**TOWN OF PORTOLA VALLEY  
ARCHITECTURAL AND SITE CONTROL COMMISSION (ASCC)  
Monday, July 13, 2015  
7:30 PM – Regular ASCC Meeting  
Historic Schoolhouse  
765 Portola Road, Portola Valley, CA 94028**

a. Architectural Review and Site Development Permit for a New Residence and Swimming Pool, File #: 01-2015 and X9H-688, 20 Minoca Road, Unger Residence (Staff: C. Borck)

**FROM:** Carol Borck, Assistant Planner

1 ROOF PLAN  
 SCALE: 1/8" = 1'-0"

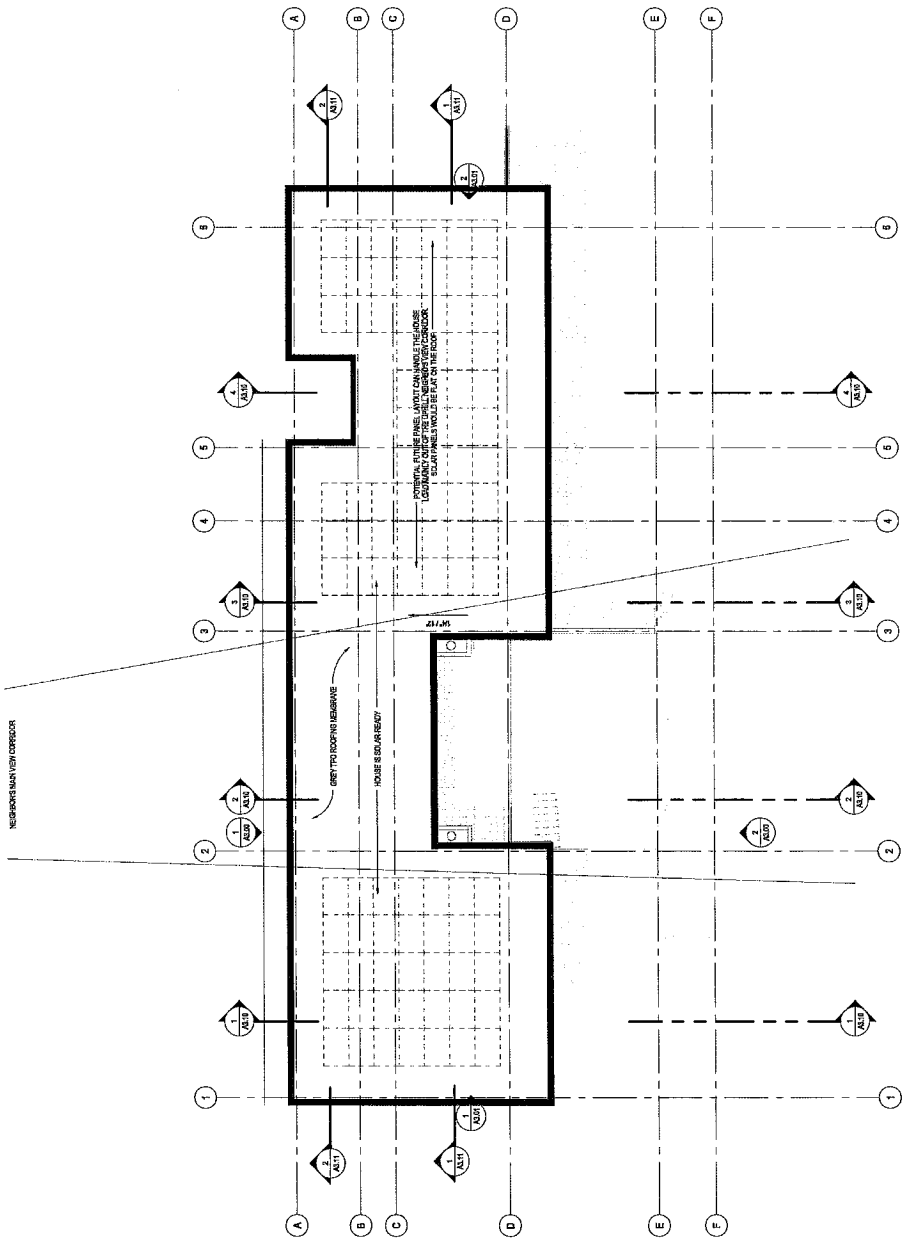
As discussed at the preliminary meeting, the house will be constructed to be "solar ready" although solar photovoltaics are not currently proposed. Sheet A2.01 has been modified to show the potential area of future roof-mounted solar panels and notes that they would be installed flush with the flat roof surface.

**D1.00**

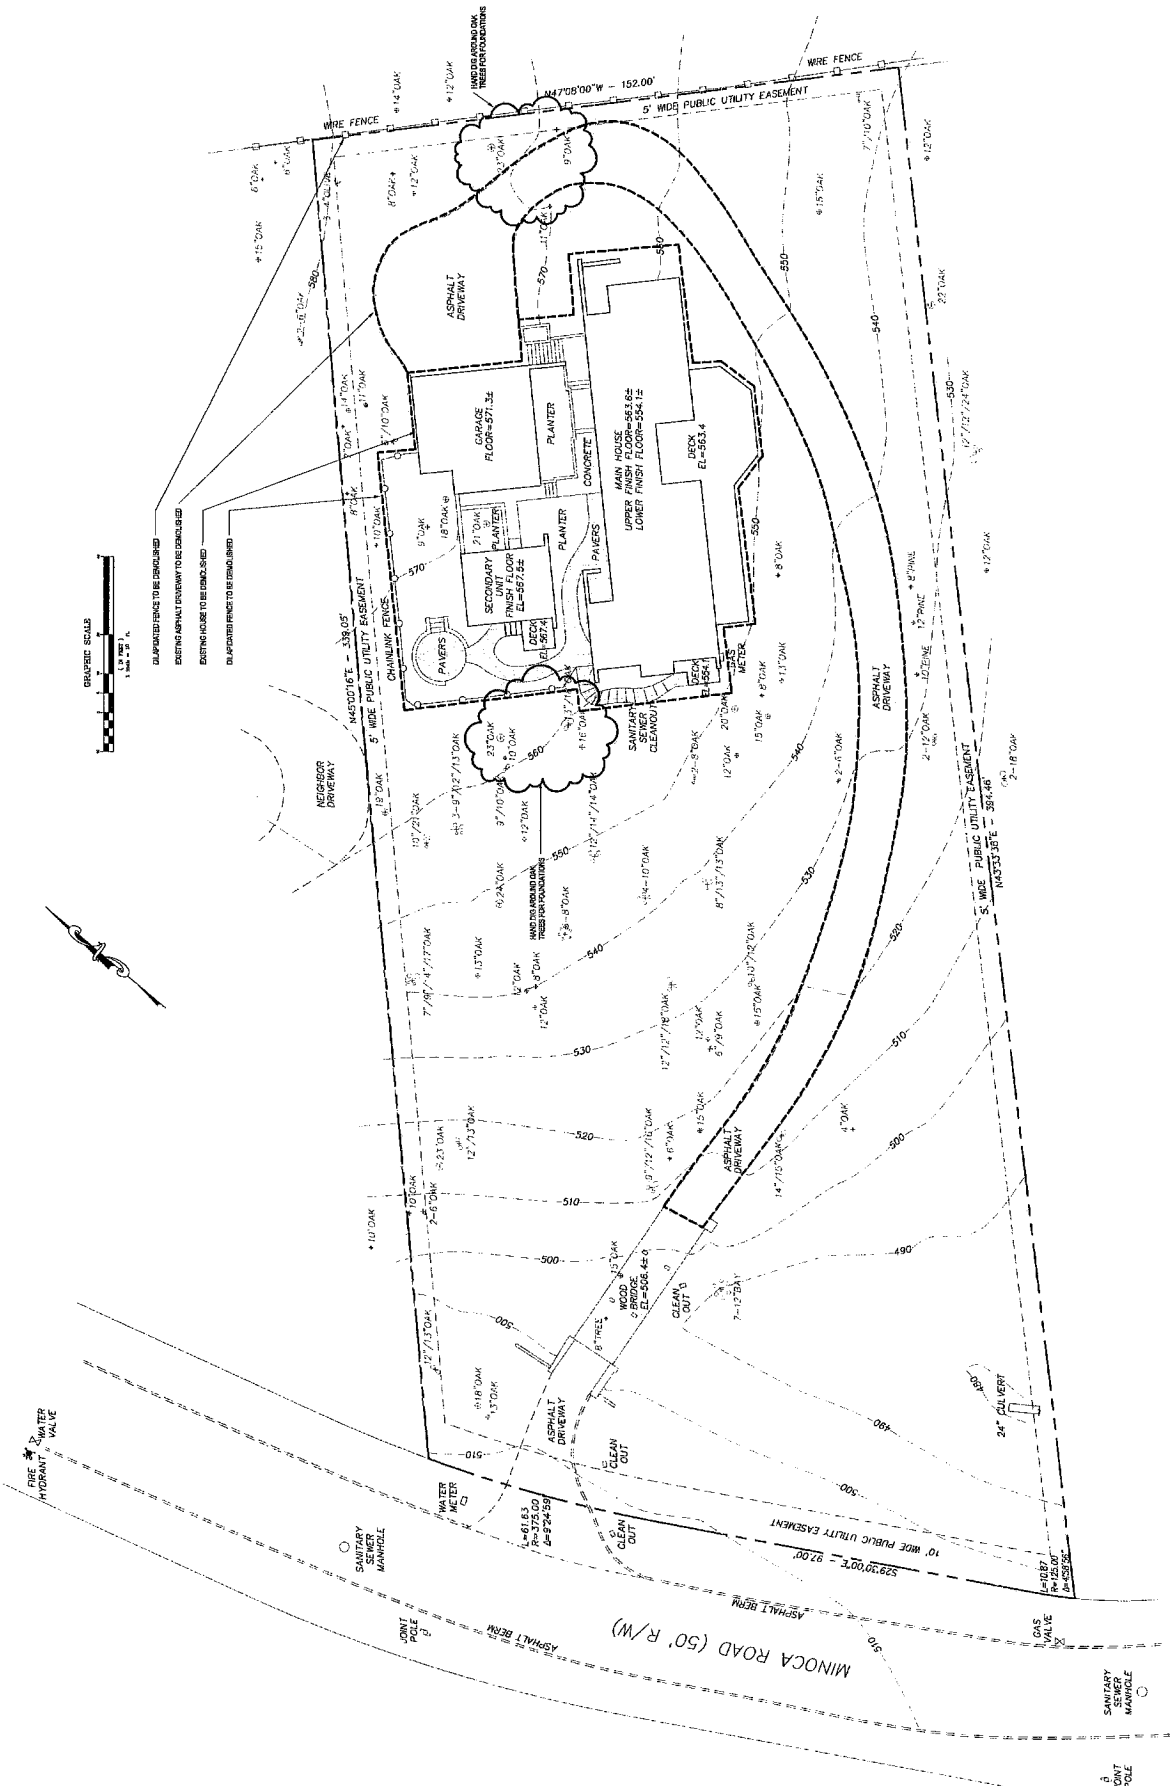
The Commission also encouraged the applicant to protect and preserve as many oaks as possible that were otherwise identified for removal. Sheet D1.00 notes that hand-digging around the 9.7" blue oak located at the driveway turnaround and at the coast live oaks located to the west of the new house will be carried out during driveway and foundation construction. The applicant also noted at the preliminary meeting that it was his intent to retain as many of the oaks as possible pending final driveway design.

- Hand digging has been noted next to oak trees that are desirable to save to protect root structures from foundation work.
- A note showing removal of the dilapidated chain link fence has been added.

LANDSCAPE PLAN  
 L-1

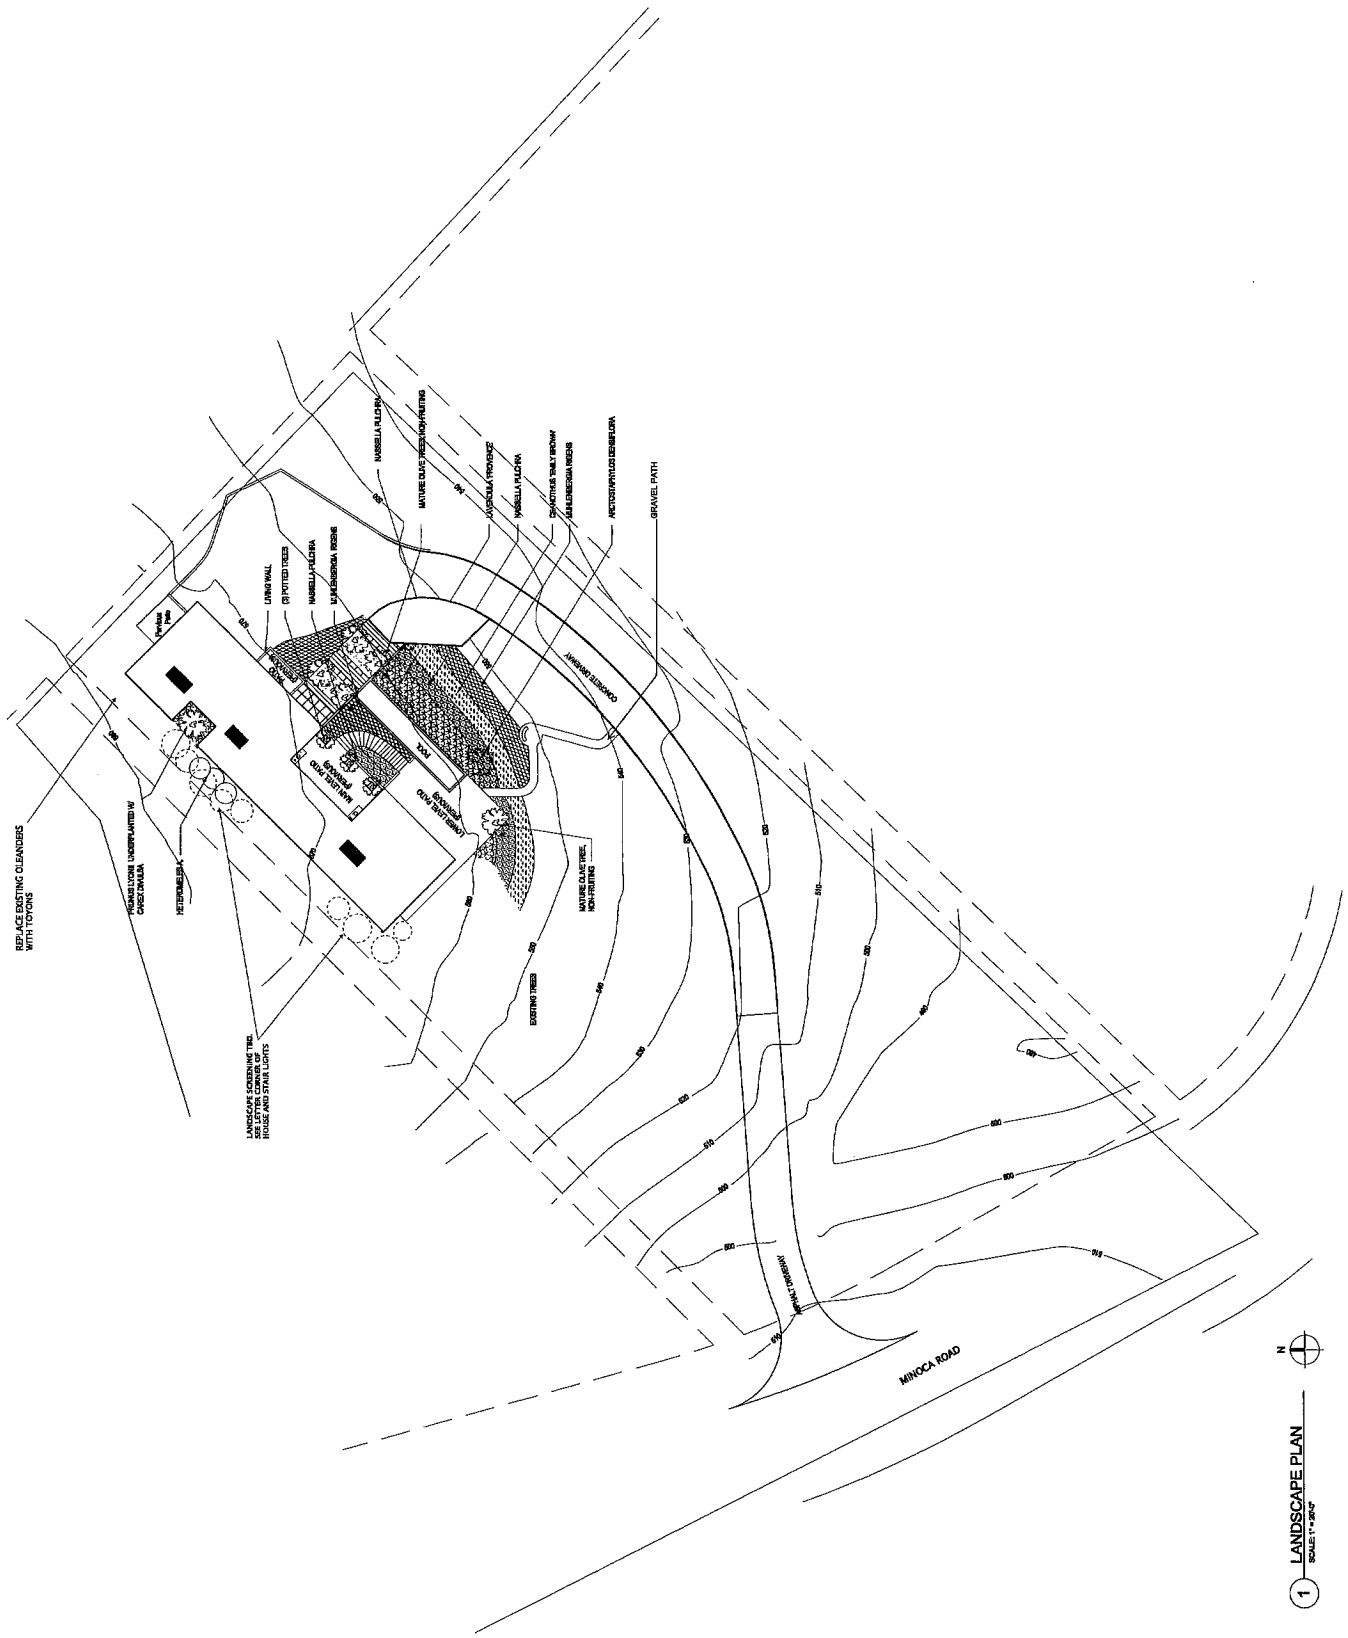
The Commission supported removal of the existing oleanders on the uphill slope, and the landscape plan has been updated to note that they will be removed and replaced with toyons. The final, detailed landscape plan will need to specify quantities and sizes of these toyons and all other proposed plantings.

- A note showing removal of Oleanders and replacing with Toyons has been added.
- Notes were added to provide landscape screening along neighbor's property at 30 Minoca.
